LOWER MINNESOTA RIVER WATERSHED DISTRICT

Technical Memorandum

Re: City of Shakopee/The Opus Group Vierling Industrial Project—Project Review (LMRWD No. 2020-112)

Figure 3: Shakopee Gateway Regional BMPs 28-June-2020

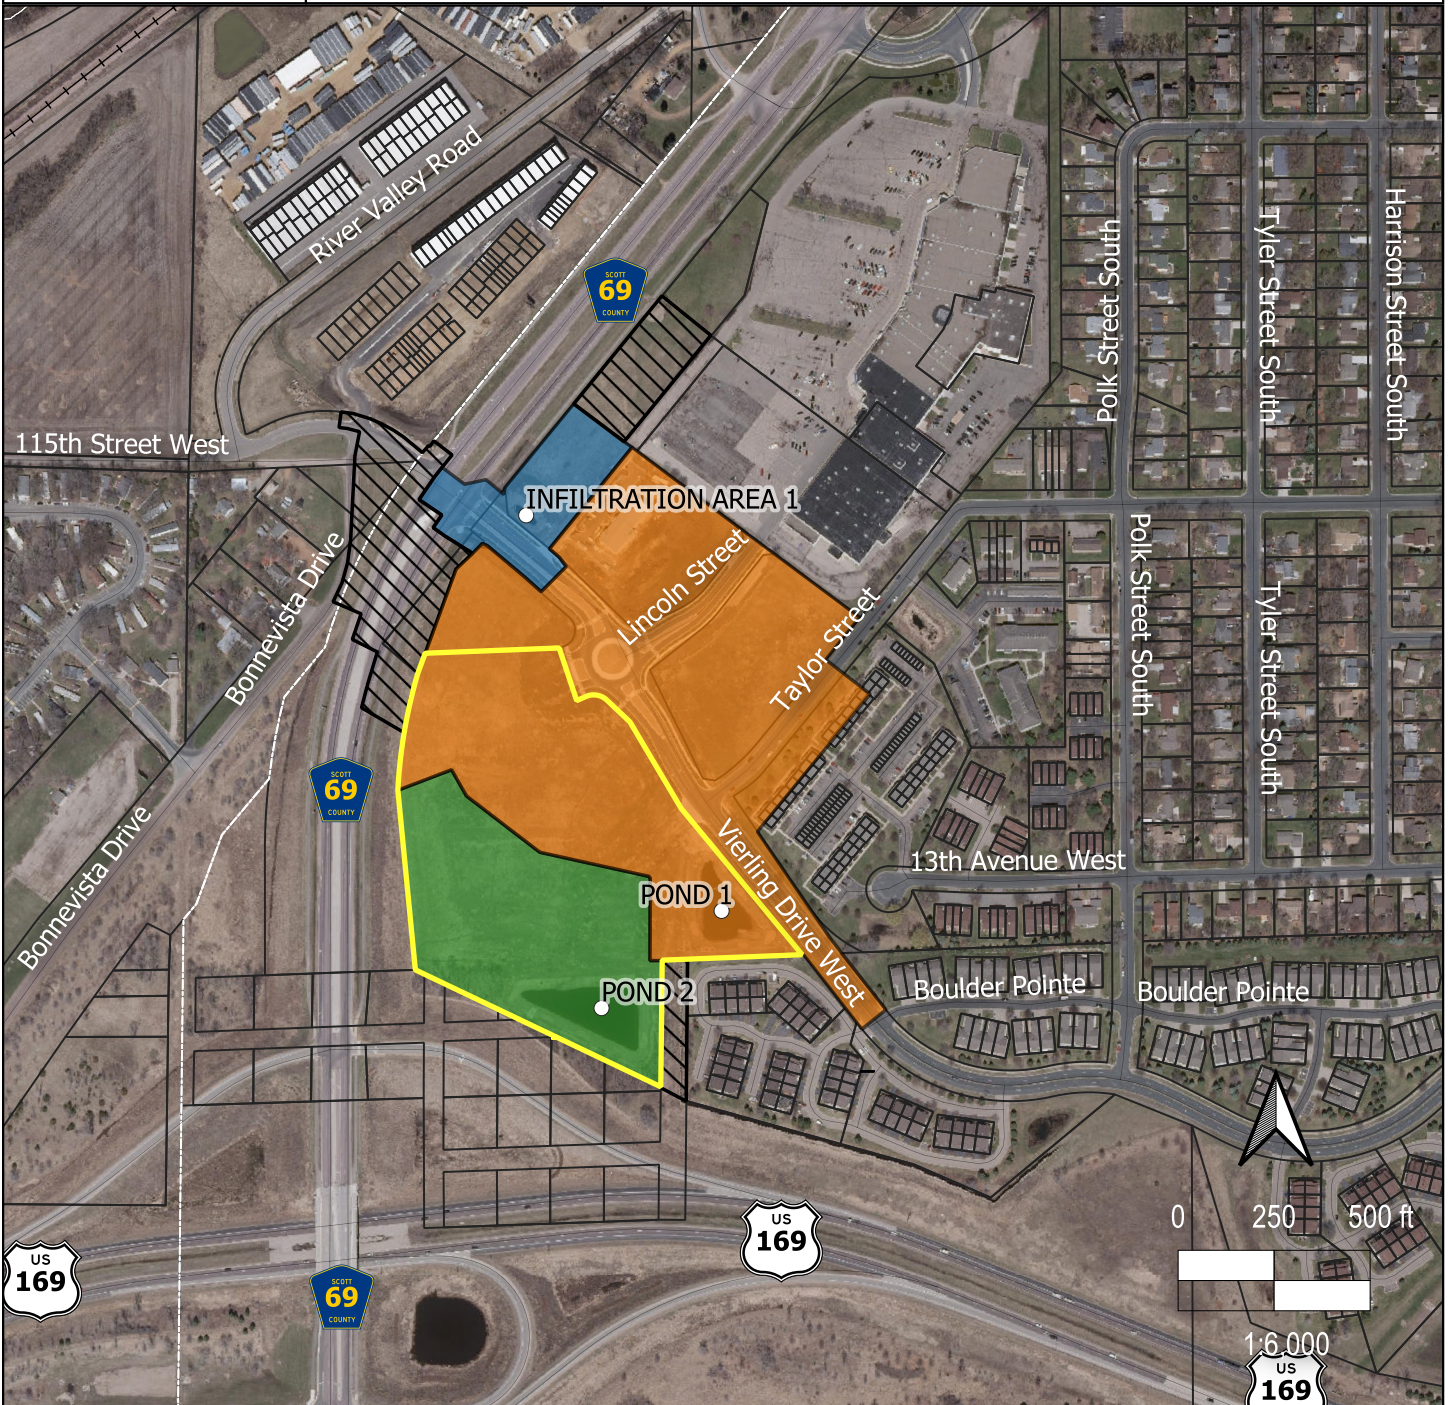
Based on our assessment of the information provided, the Infiltration Area 1 BMP has exceeded its impervious area capacity; however, as previously discussed, according to the City, the developer constructed additional water quality BMPs to account for this shortfall, though we were unable to confirm this. The remaining BMPs, Pond 1 and Pond 2, both have capacity to provide treatment for future development.

The proposed Vierling Industrial project is located within the original design subcatchments S-2A and S-2B from the 2018 *Vierling Drive/Lincoln Street Hydraulic Report* and will be treated by Ponds 1 and 2 (**Figures 3 and 4**). A summary of the design, including impervious and proposed impervious areas, is provided below in **Table 3**.

Though Vierling Industrial will cause Subcatchment S-2A to exceed the original design's impervious area assumption for Pond 1 because of changes in the final site grading for the Vierling Industrial project, Pond 1 has the capacity to treat this additional impervious area. It should be noted, however, that this may limit future development in the Shakopee Gateway area and cause subsequent developments to be required to construct private BMPs onsite because the excess impervious area proposed by Vierling Industrial in Subcatchment S-2A will reduce the remaining capacity for future projects beyond the original design assumption.

FIGURE 4 - STORMWATER DELINEATION MAP FROM 2018 VIERLING DR/LINCOLN ST HYDRAULIC REPORT (WSB & ASSOCIATES)

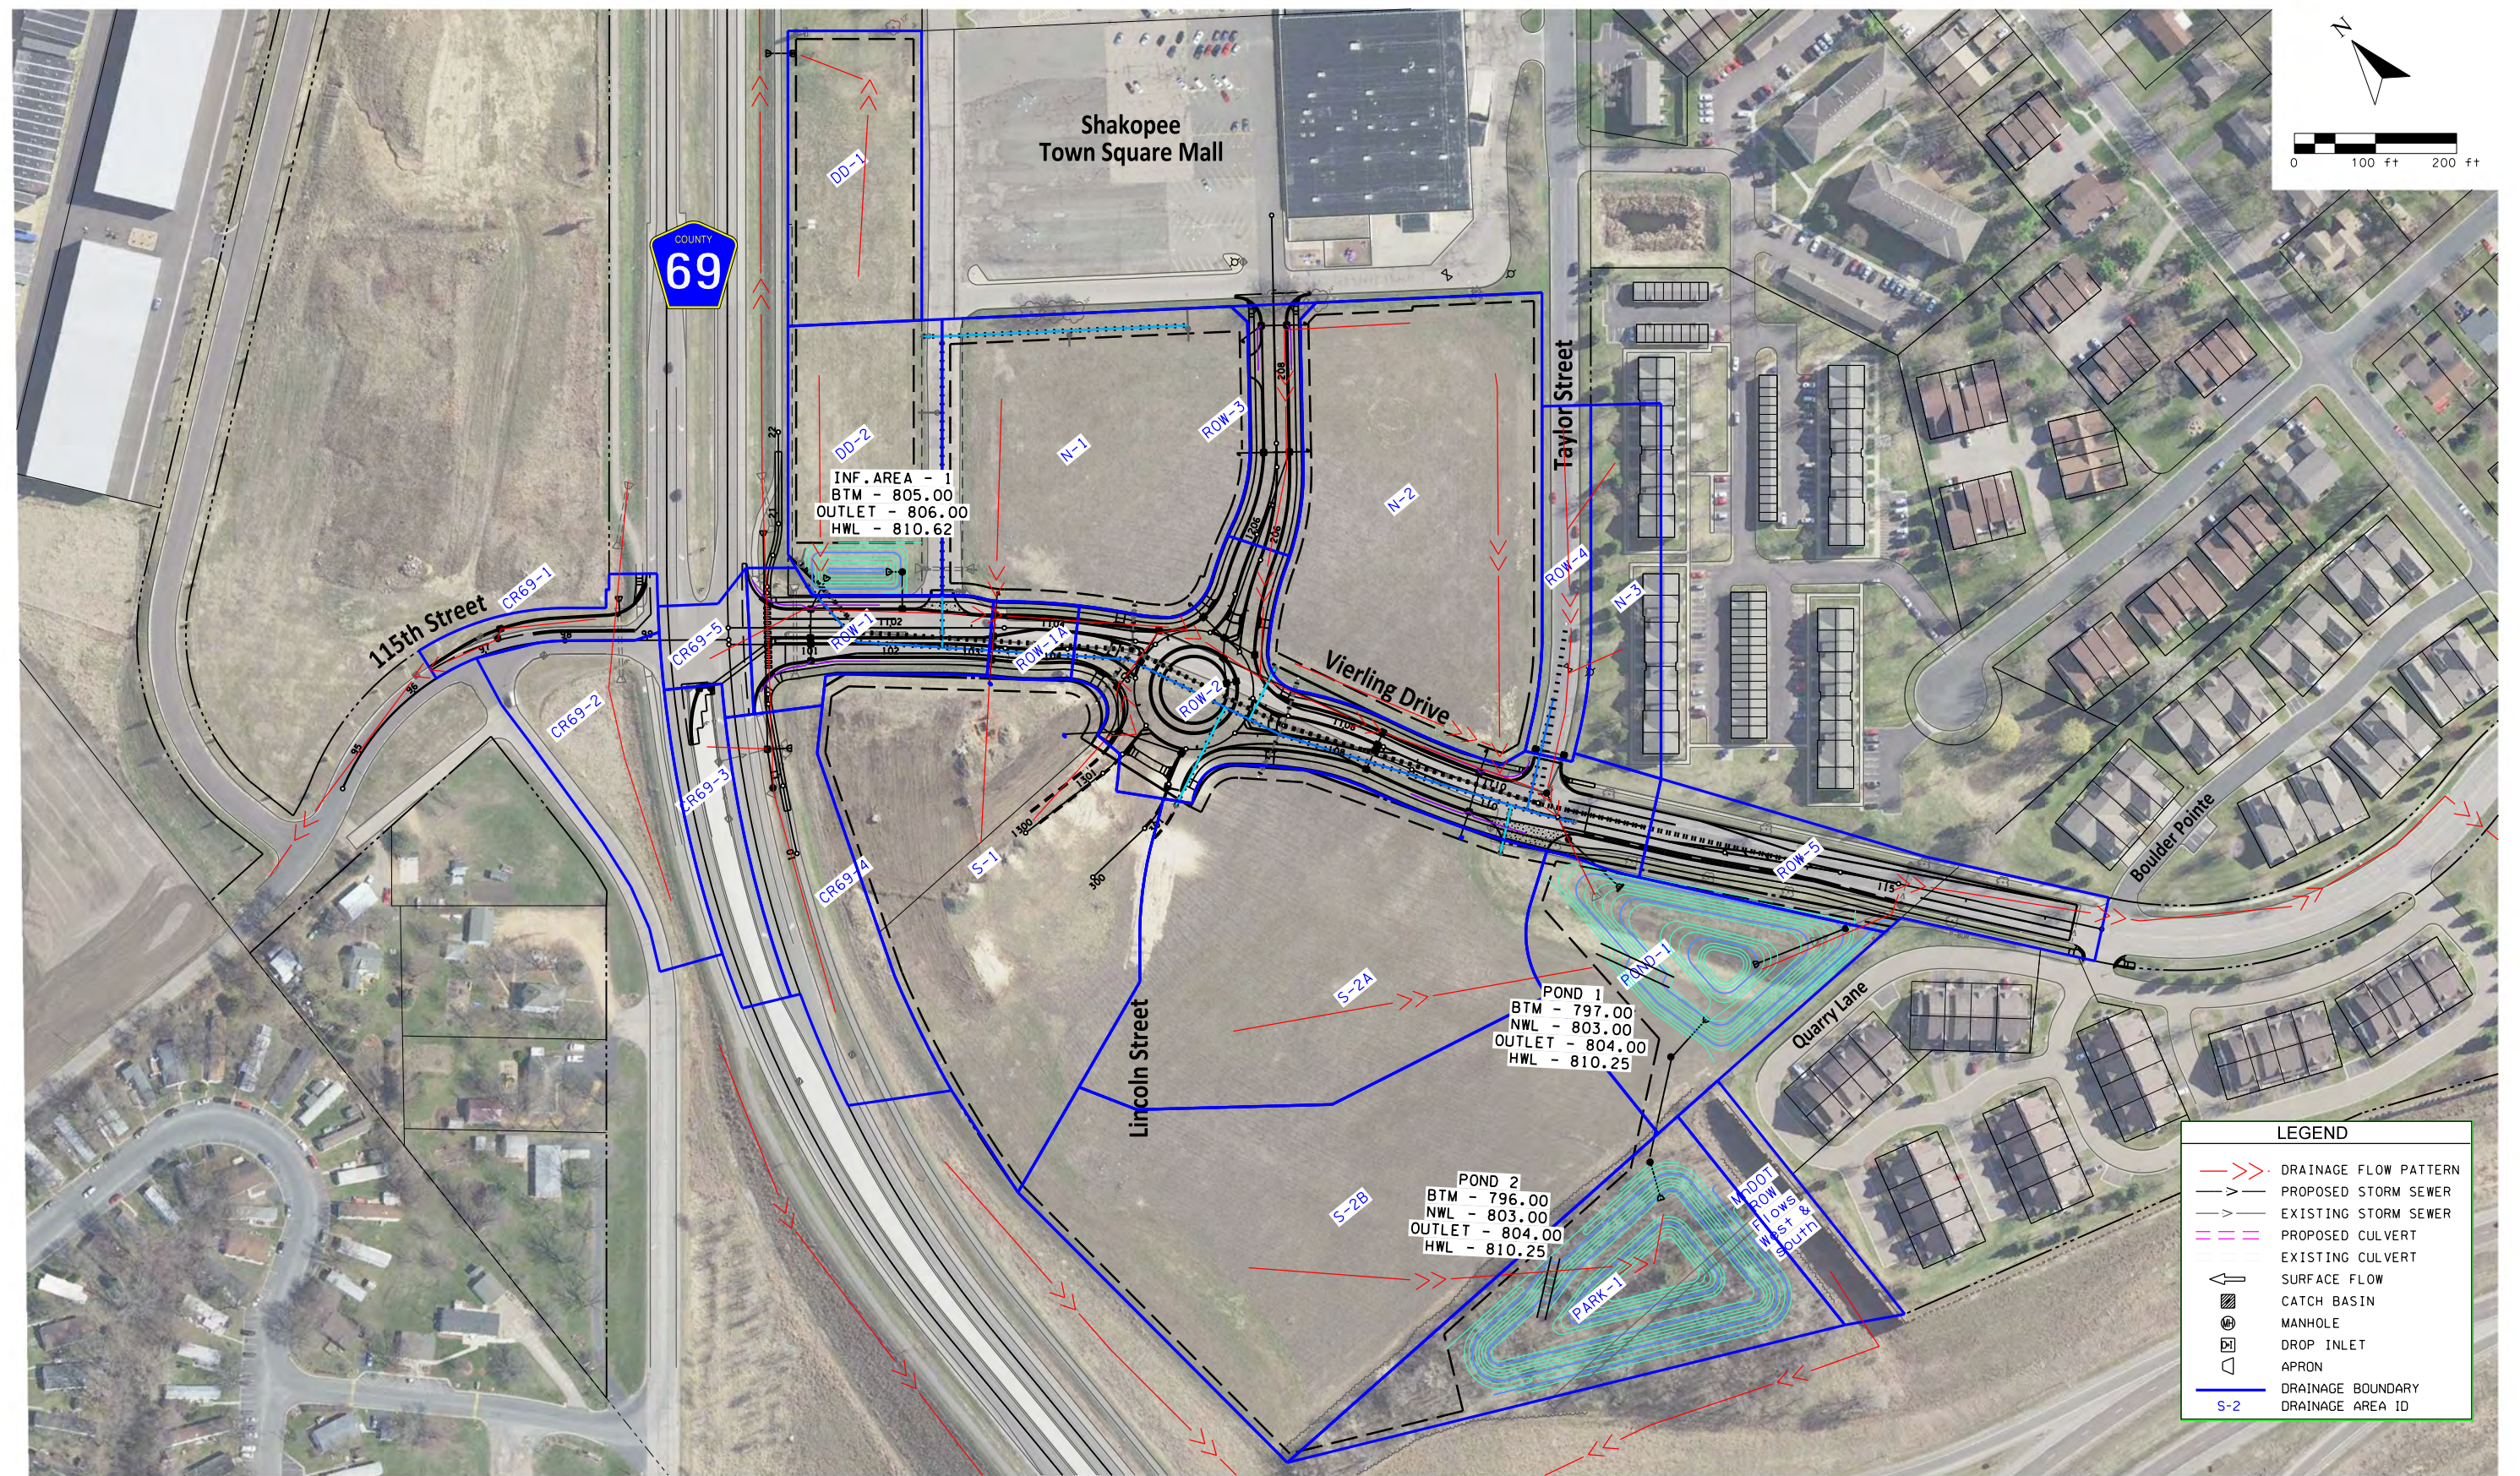
The *Vierling Drive/Lincoln Street Hydraulic Report*, developed by WSB for the Vierling Corridor Improvement project, includes the original design drainage areas ([Figure 4](#)) and summary stormwater management plan (SWMP) for the entire Shakopee Gateway

development, as well as HydroCAD modeling output. A review of the provided documents indicates that the original design was based on the maximum impervious area assumed for each subcatchment and each individual BMP. A future project is believed to conform to the original design if the proposed impervious area does not exceed the assumed impervious areas of the subcatchment and the BMP provided in the summary SWMP table (attached).
